ADDENDUM NO. 1
CITY OF DERMOTT
WATER LINE REPLACEMENT AND EXTENSIONS
10 January 2024

Replace sheets 2 – 6, 16, 22 – 25, and 37 – 38 with the attached sheets. (Revised placement of insertion valves and connection at tank).

**CITY OF DERMOTT
WATER SYSTEM REPLACEMENT
AND EXTENSIONS
PLANS**

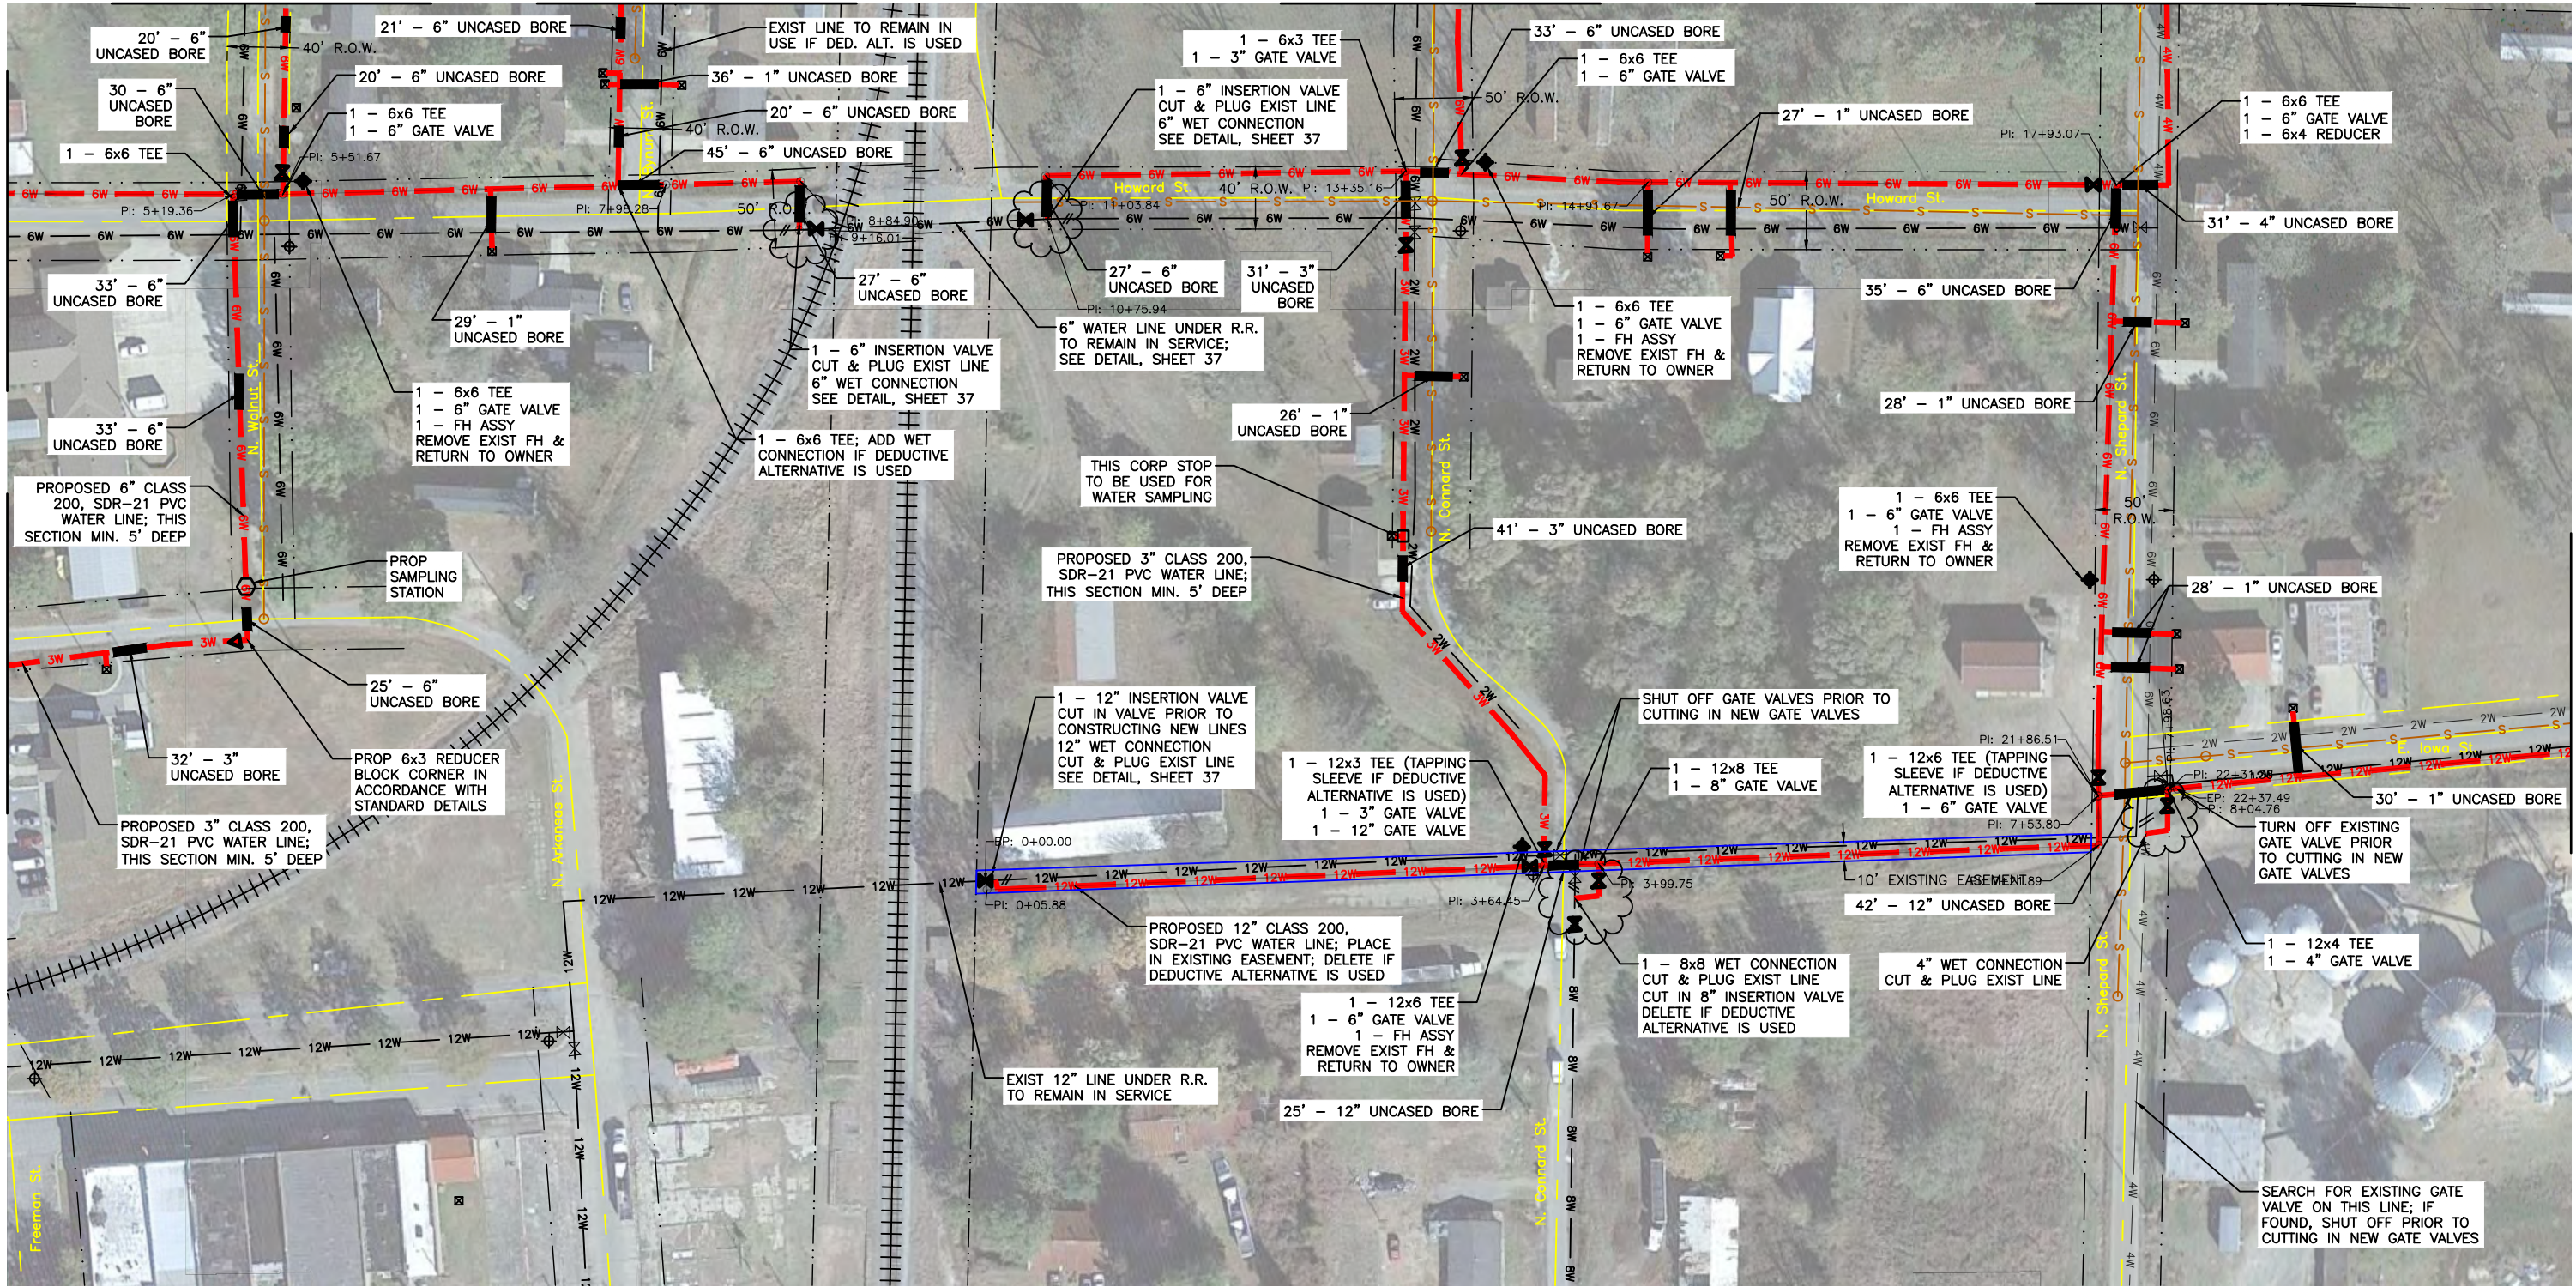
A-1	ADDENDUM - POSITION OF INSERTION VALVES	01/2024	DESIGNED BY WRG	CHECKED BY
	MOVE CERTAIN LINES TO OTHER SIDE OF STREET	12/2023	DRAWN BY JKD	APPROVED BY
	ADD STATIONING TO CERTAIN LINES	10/2023	DATE: 12-2022	JOB NO:
REV.	DESCRIPTION	CHK.	DATE	APP.
				SCALE: 1" = 50'
				DRAWING NUMBER: 23
				REV. 0

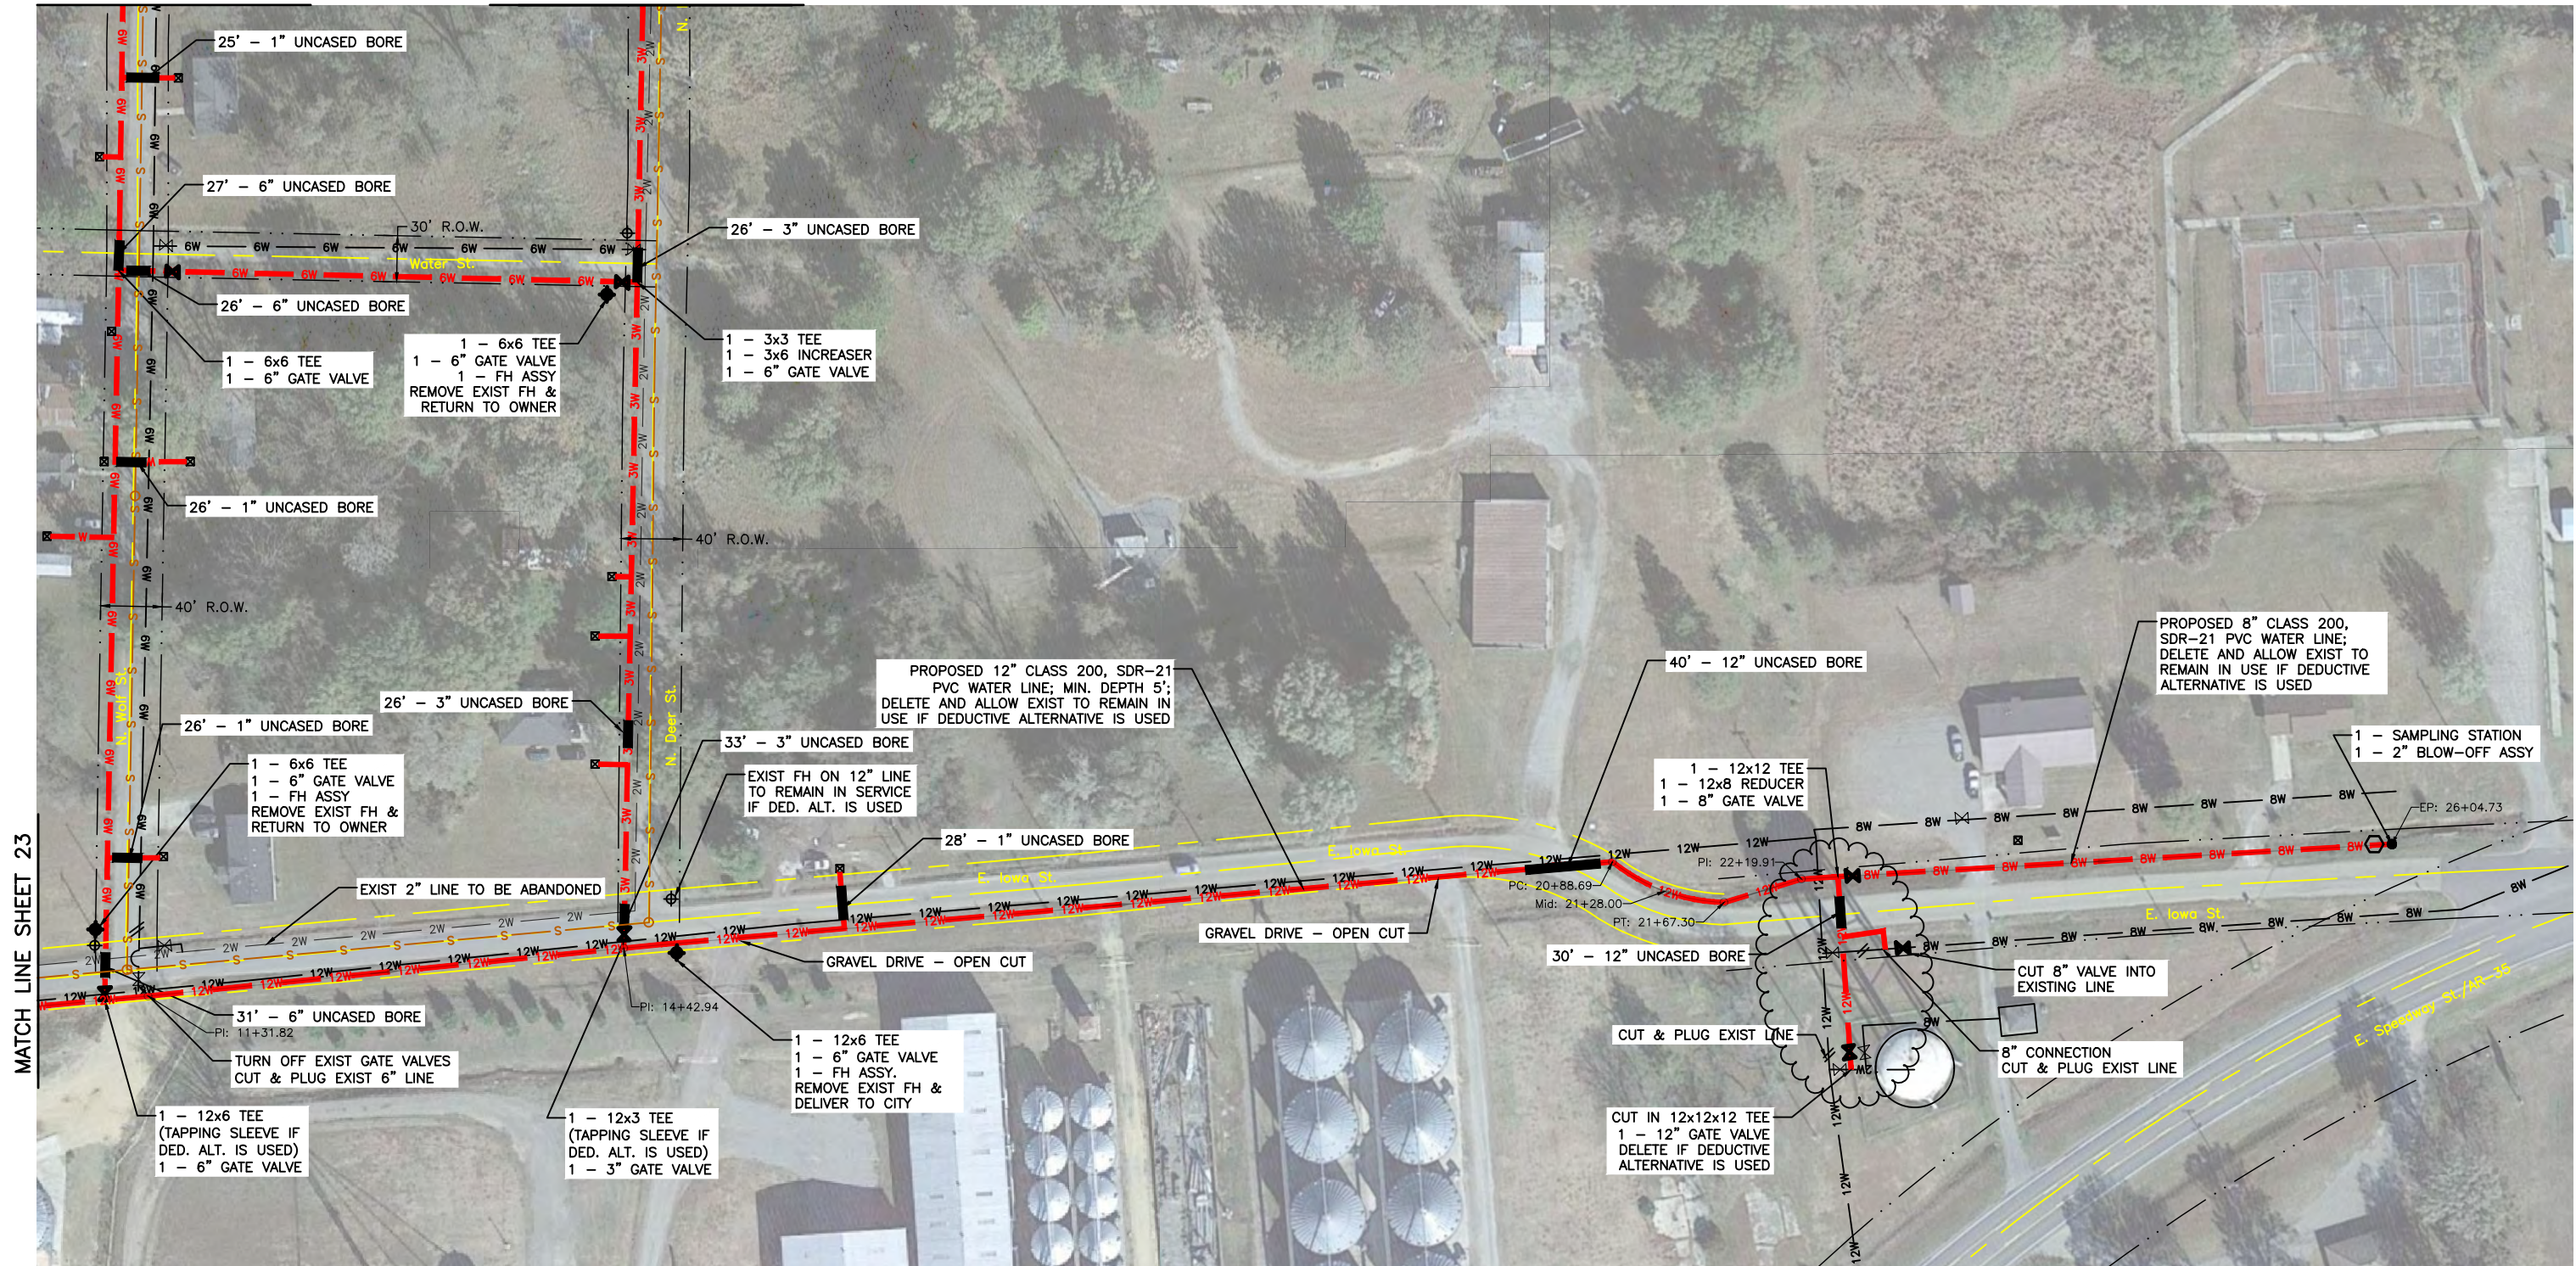
REV.	DESCRIPTION	CHK.	DATE	APP.	DATE	DESIGNED BY	WRG	CHECKED BY	
A-1	REVISE CONNECTION AT TANK		01/2024			DRAWN BY	JKD	APPROVED BY	
	MOVE CERTAIN LINES TO OTHER SIDE OF STREET		12/2023			DATE: 12-2022	JOB NO:	ITEM NO:	
	ADD STATIONING, MOVE LINE INSIDE R.O.W.		10/2023			SCALE	DRAWING NUMBER	REV.	
						1" = 50'	24	0

CITY OF DERMOTT
WATER SYSTEM REPLACEMENT
GENERAL LAYOUT
DEDUCTIVE ALTERNATIVE

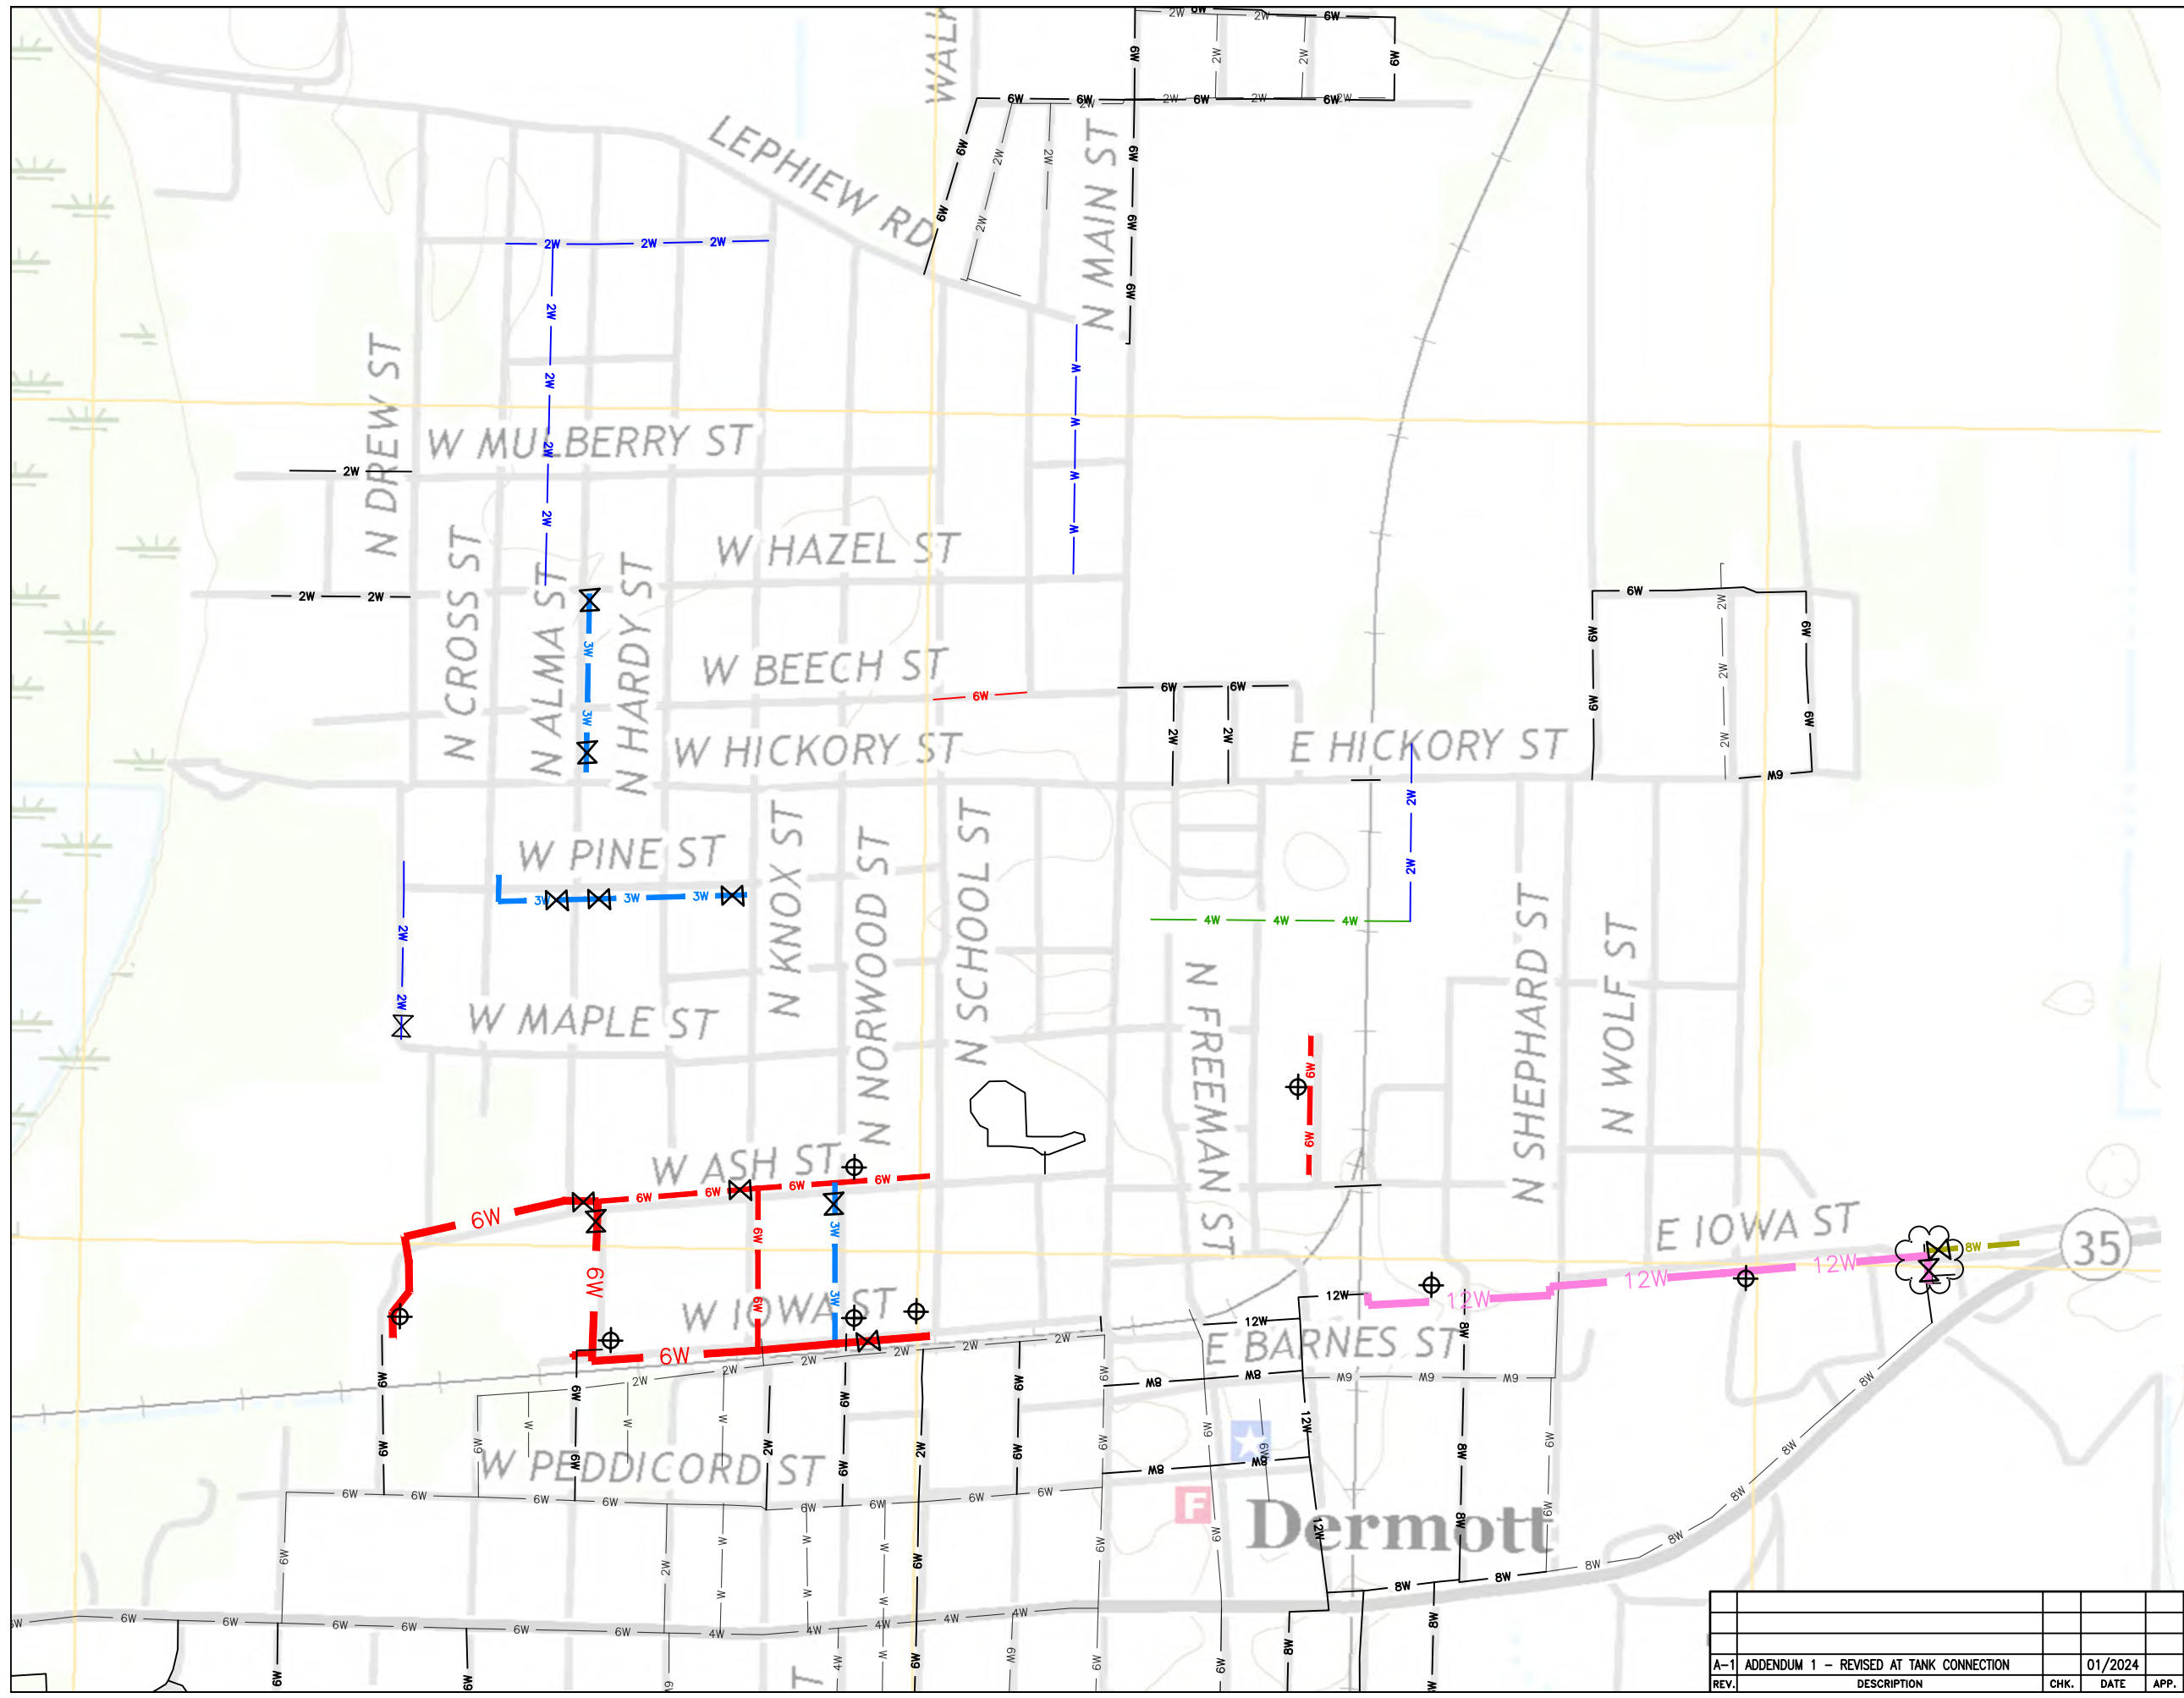
A-1 ADDENDUM 1 - REVISED AT TANK CONNECTION	01/2024	DATE	APP.	DATE
REV.	DESCRIPTION	CHK.	DATE	APP.

**CITY OF DERMOTT
WATER SYSTEM REPLACEMENT
RAILROAD CROSSING DETAILS**

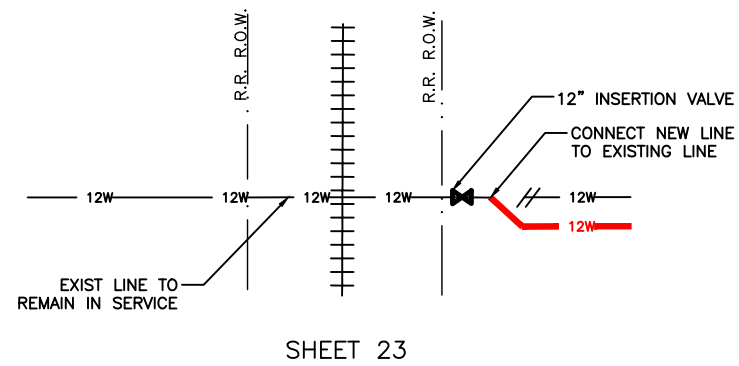
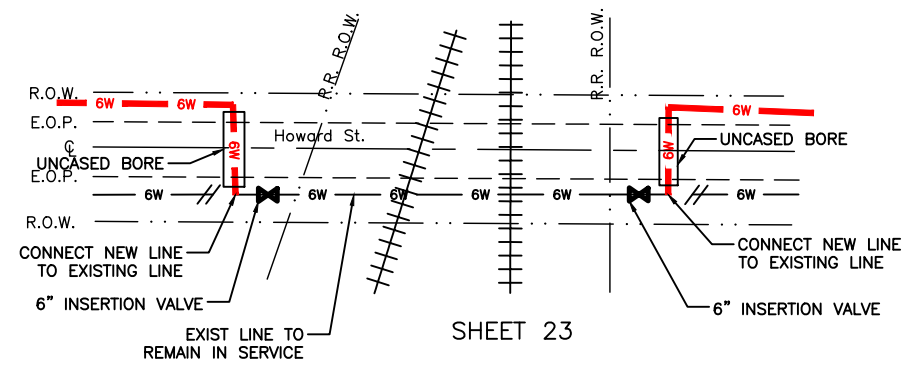
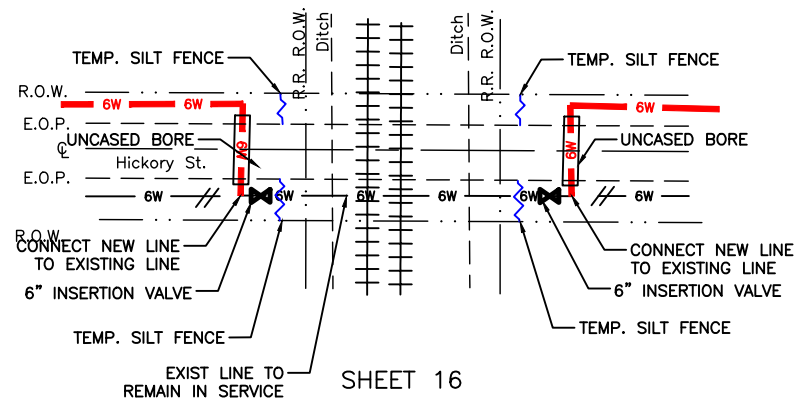
REV.	DESCRIPTION	CHK.	DATE	APP.	DATE
A-1	ADDENDUM 1 -- POSITION OF INSERTION VALVES		01/2024		
	MOVED CERTAIN LINES TO OTHER SIDE OF STREET		12/2023
